**JUSTIFICATION LETTER FOR MINOR AMENDMENT TO SITE DEVELOPMENT PLAN
APPROVAL PRIOR TO EFFECTIVE DATE OF THE IDO.**

DRB No.: 1011638
IDO Zoning: NR-BP
Legal Description: Lot 22-A, Block No. 8, original Townsite of Westland, being a replat of Lot 22, Block 8 within Town of Atrisco Grant, Bernalillo County.

L&C TRANSPORT OFFICE AND SHOP

MINOR AMENDMENT TO SITE DEVELOPMENT PLAN
APPROVED PRIOR TO EFFECTIVE DATE OF IDO

BUILDING ELEVATIONS - SHOP / SHADE
STRUCTURE

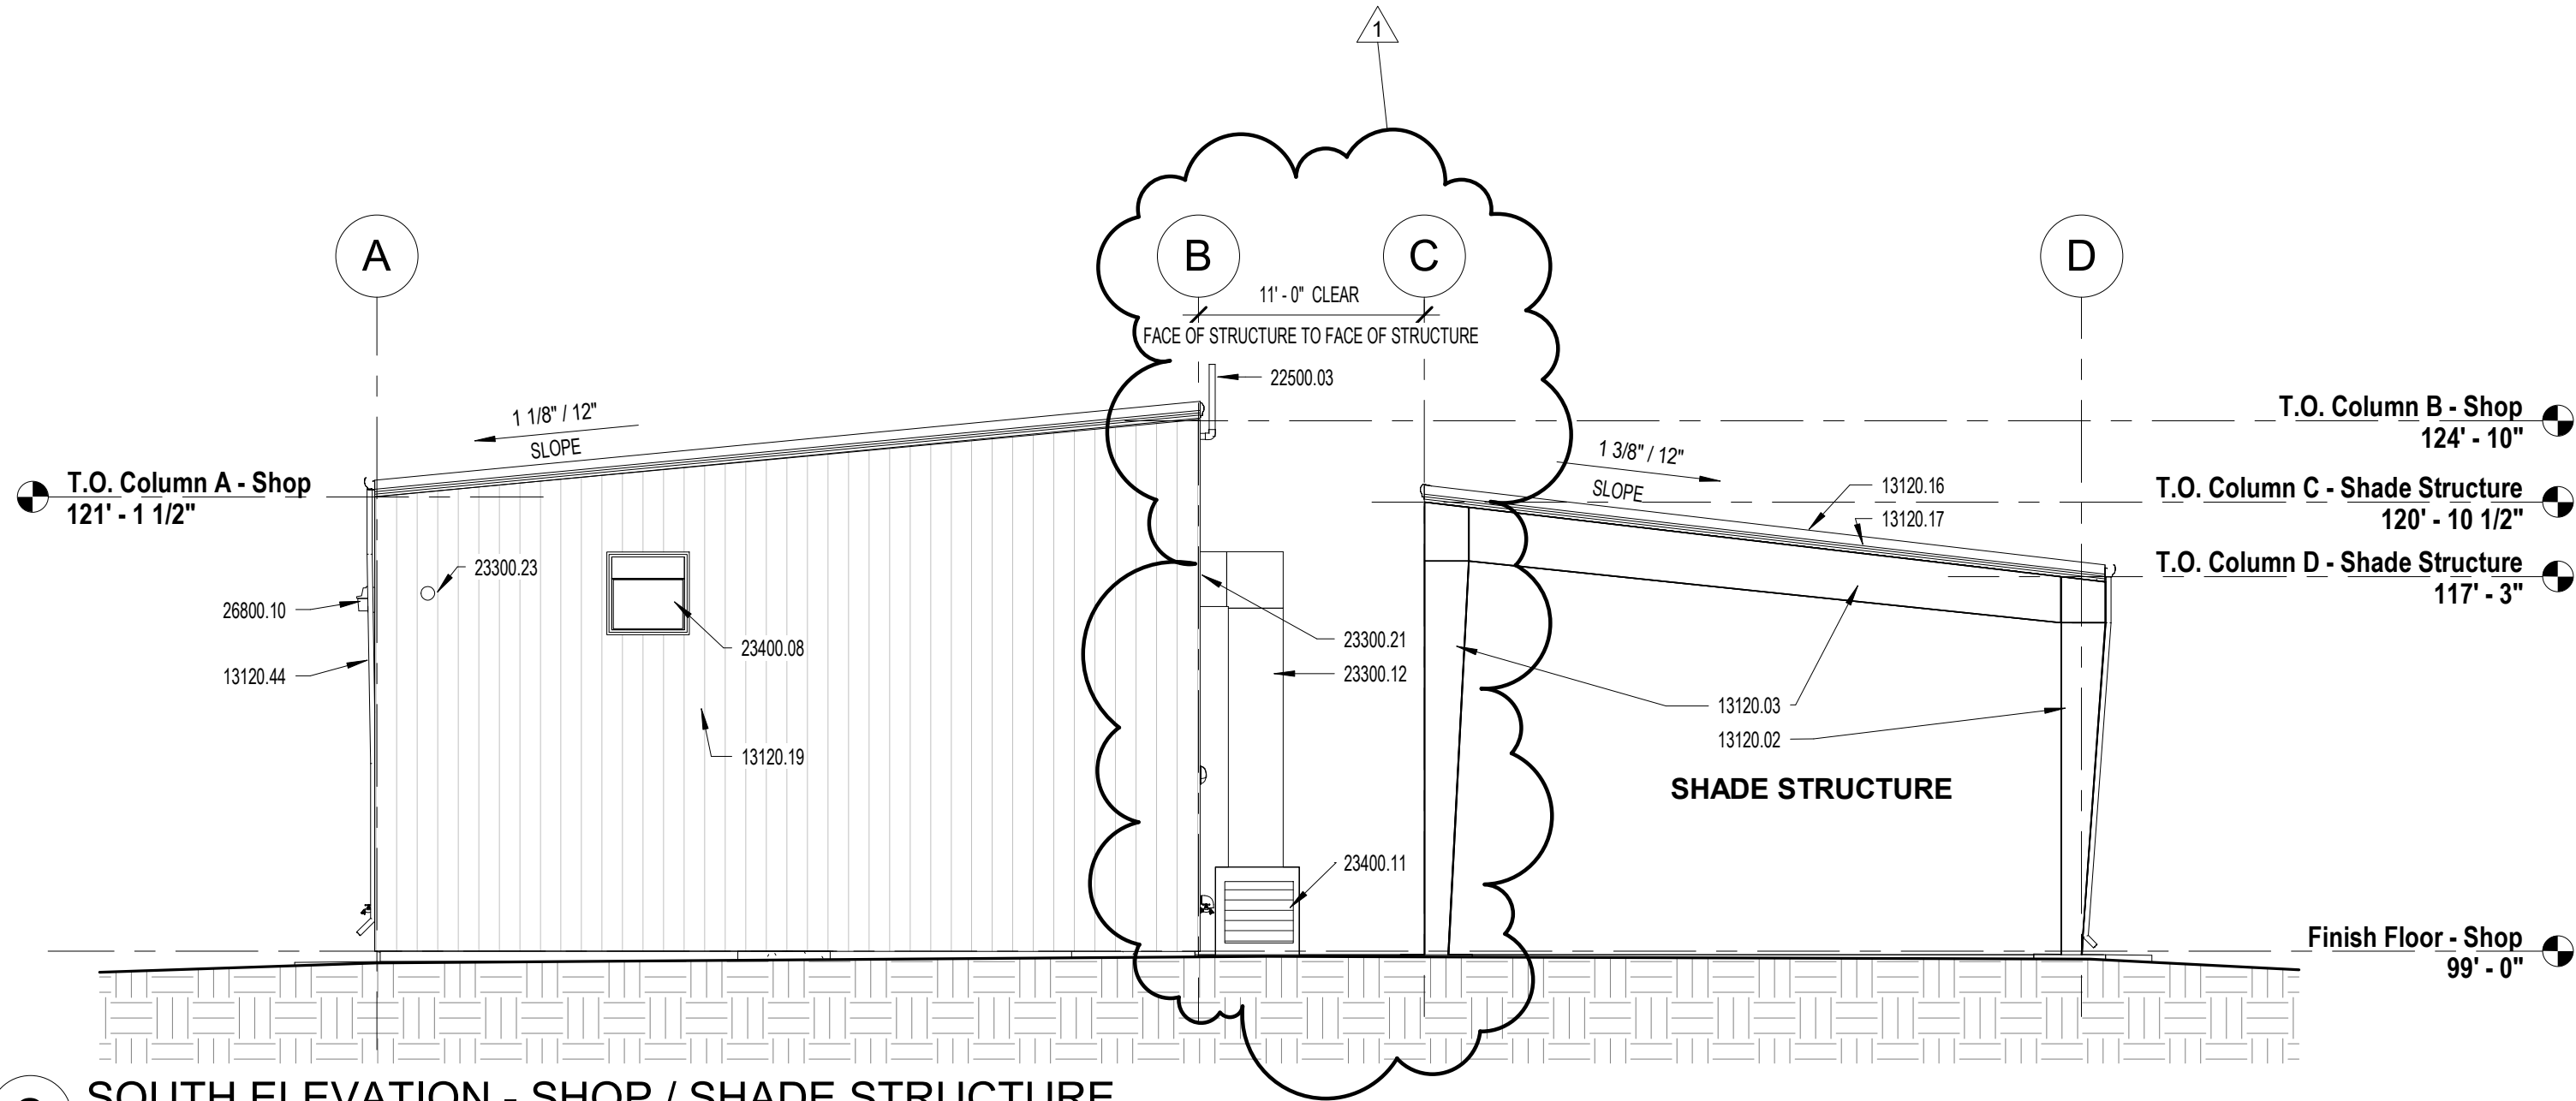
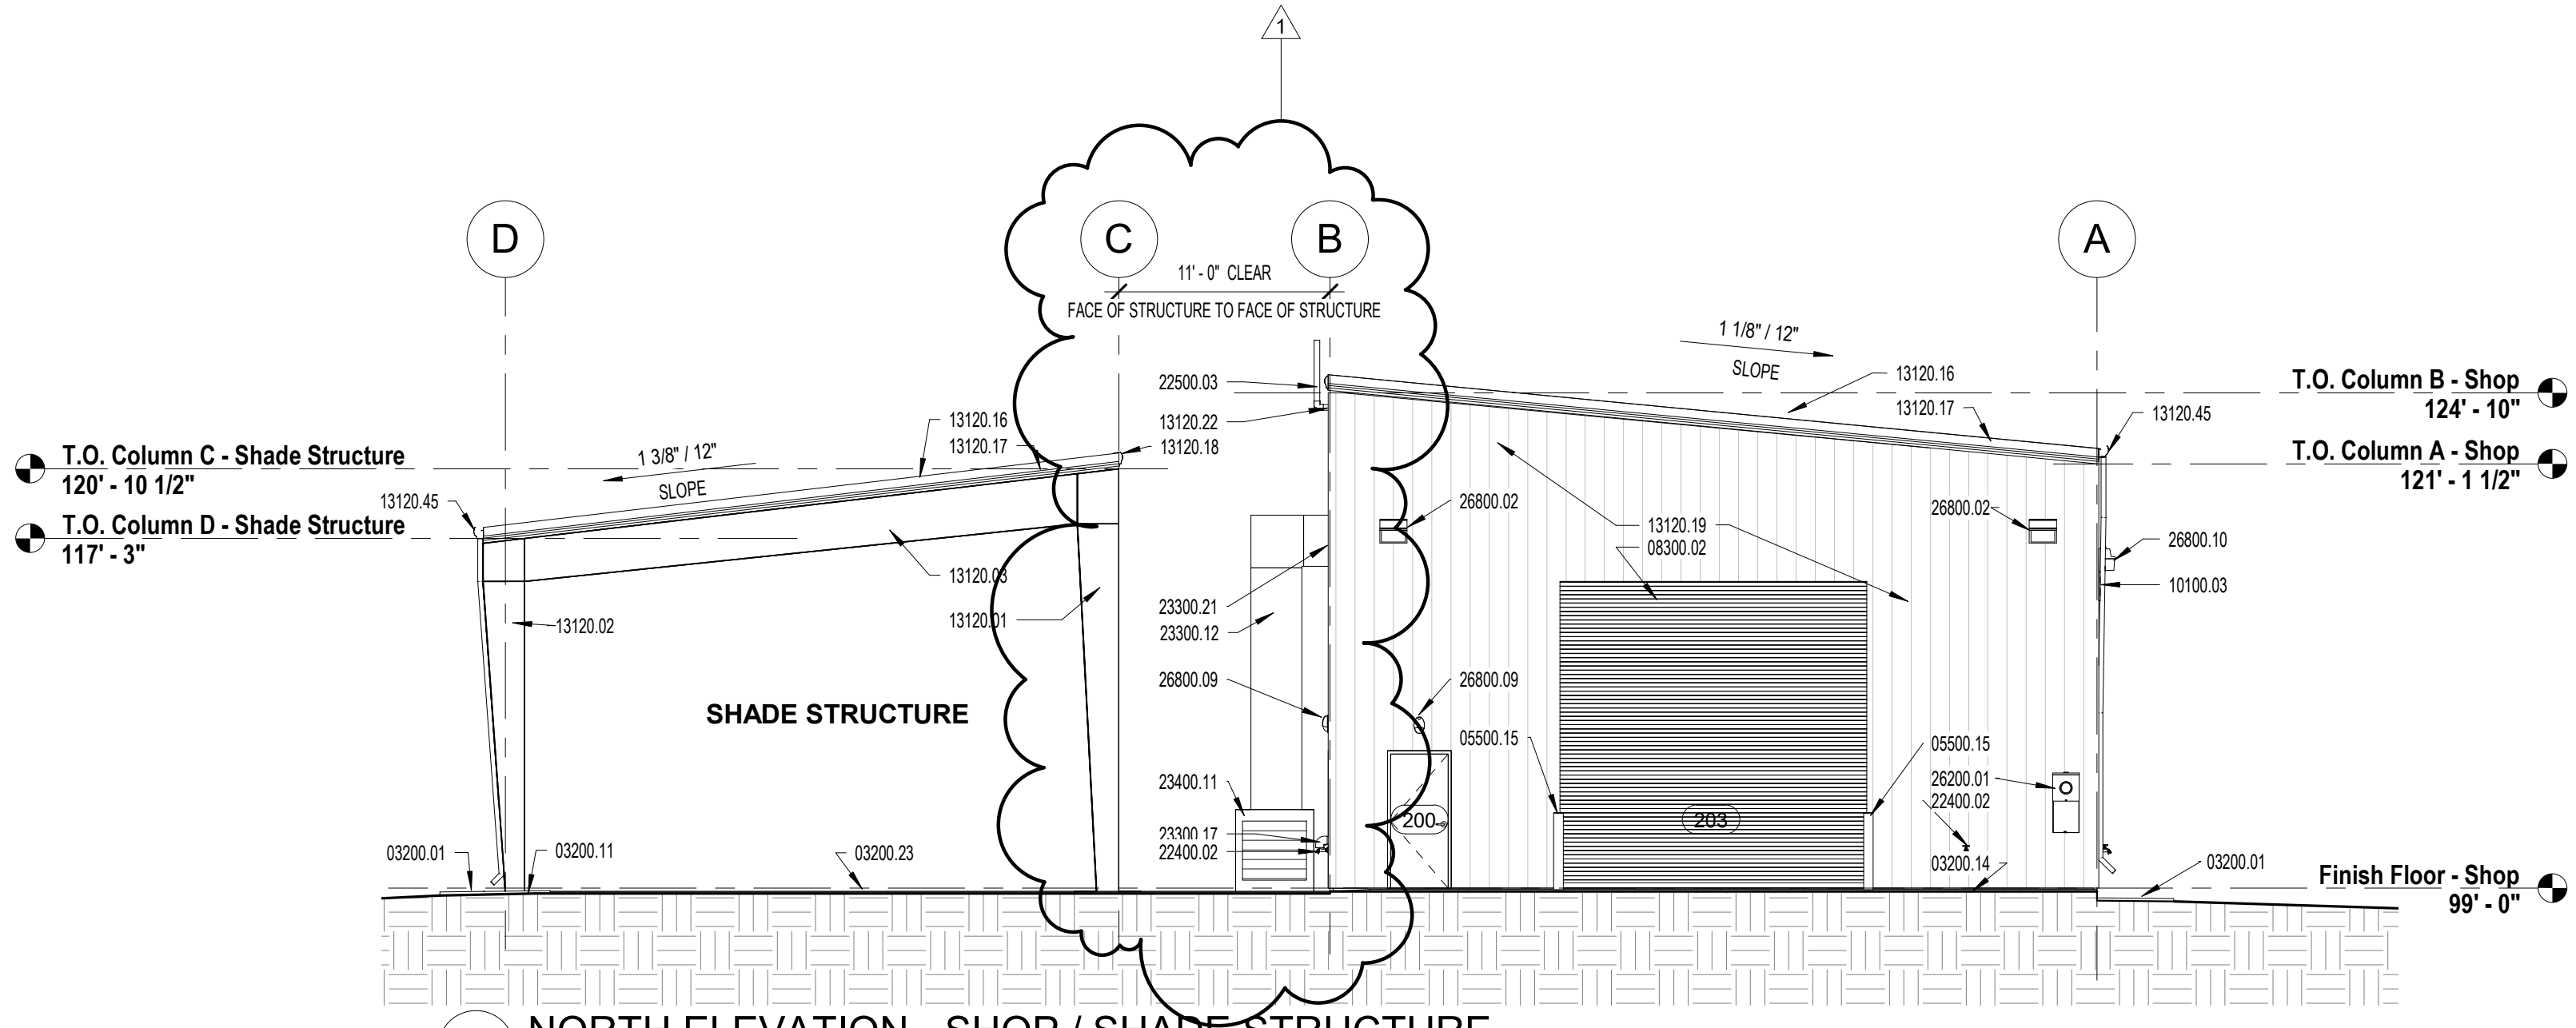
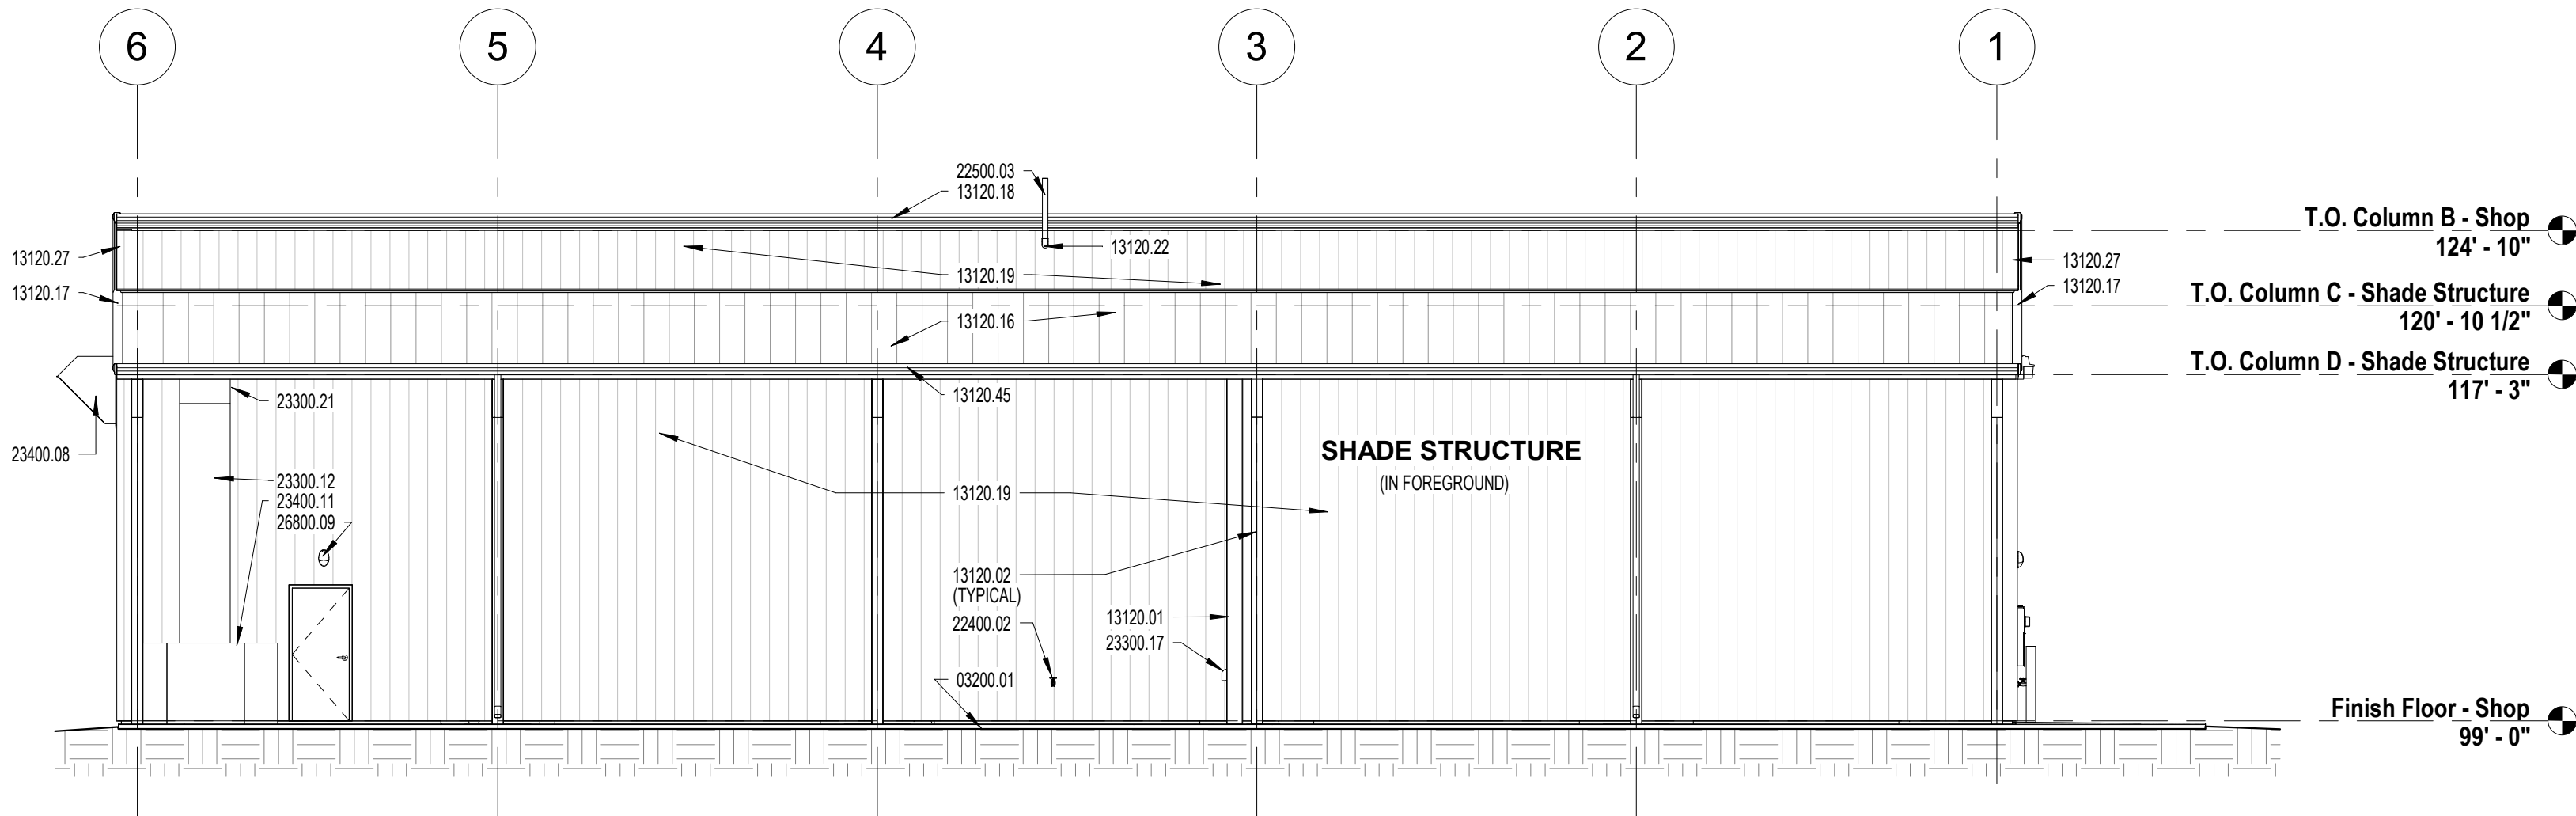
PROPOSED CHANGES PER THE MINOR AMENDMENT TO SITE DEVELOPMENT PLAN INDICATED BY THIS SHEET

1. THE SHADE STRUCTURE IS A SEPARATE STRUCTURE FROM THE SHOP BUILDING PER THE APPROVED BUILDING PERMIT SET.

1 Landscape Plan
1" = 20'-0"

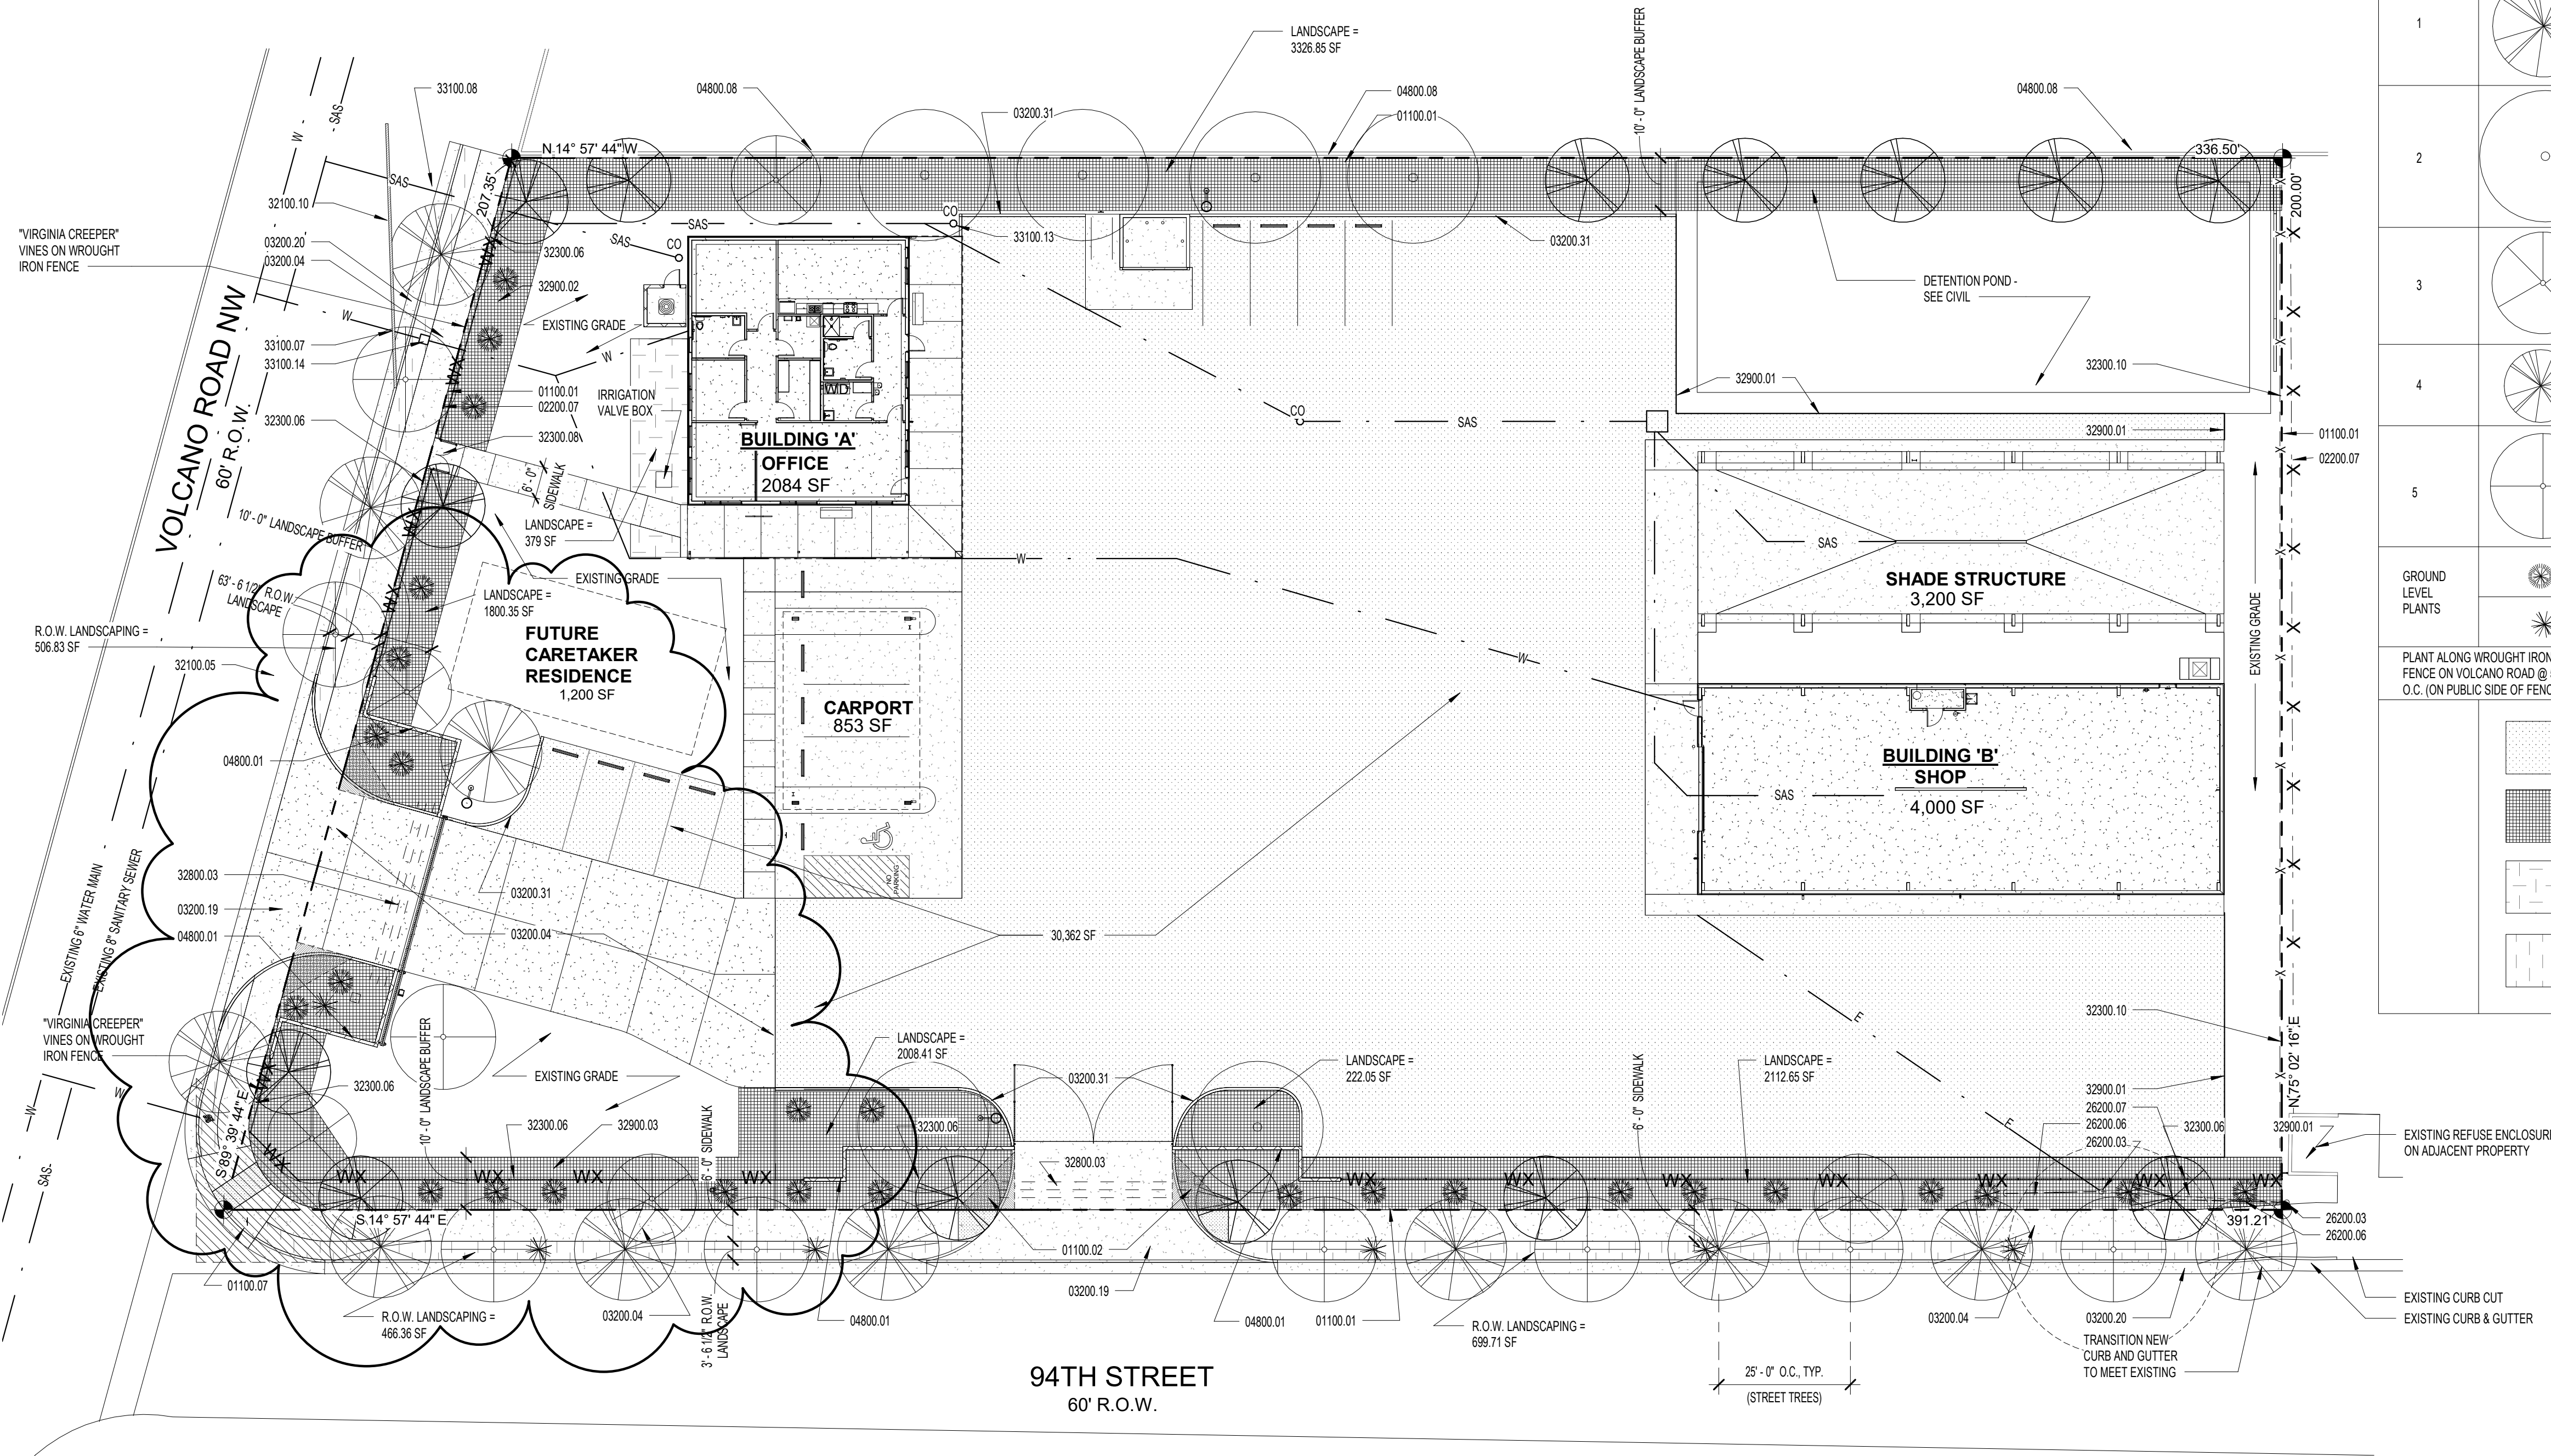
DESCRIPTION:
THIS MINOR AMENDMENT IS FOR THE CONSTRUCTION OF AN ADDITIONAL DRIVEWAY
ENTRANCE INTO THE PROPERTY, RELOCATION OF THE PEDESTRIAN GATE AND SIDEWALK
INTO THE PROPERTY, AND MINOR CHANGES TO THE LANDSCAPING TO ACCOMMODATE THE
NEW DRIVEWAY.
